ADA Curb Ramp New Construction Inspection Form (Perpendicular)

Nw 291 st

23885.56

Nw king ave

PERPENDICULAR RAMP (PR)

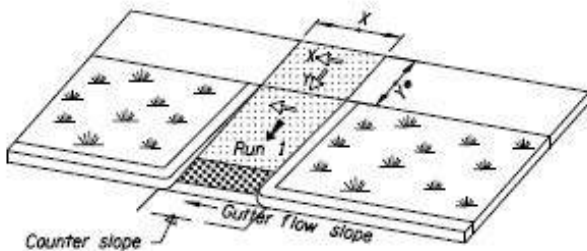
Rr1 icrr tool joints in turn space
